Service Bulletin

Subject: UNABLE TO LOWER REAR SEATBACK WITH REMOTE HANDLE / SEATS HARD TO LOCK	Bulletin No: 09-013/13 Last Issued: 10/24/2013
---	---

- This bulletin supersedes the previous bulletin 09-013/13 issued 04/29/13 and 09-042/12 issued 11/07/12. The APPLICABLE MODEL(S)/VINS, DESCRIPTION, REPAIR PROCEDURE, PART(S) and WARRANTY INFORMATION have been revised.
- Changes are noted below in Red beside the change bar.

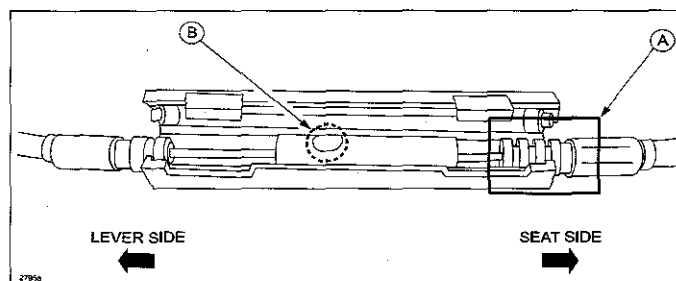
- Insufficient remote cable tension due to incorrect adjustment position (A) of the remote cable.
- The cable ball (B) gets seized on sharp edges inside the cylinder.

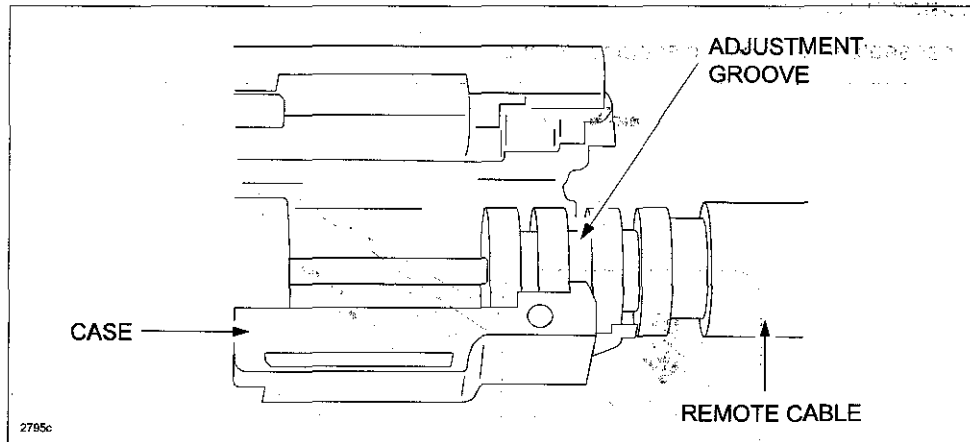
3. Replace the remote handle lever assembly (including the remote cable) according to the online MS3 instruction or the Workshop Manual (section 09-13 REMOTE HANDLE LEVER REMOVAL/INSTALLATION).

4. Set the adjustment groove to the position where the malfunction does not occur according to the online MS3 instruction or the Workshop Manual (section 09-13 REAR SEAT REMOVAL/INSTALLATION - Remote Cable Adjustment Procedure).
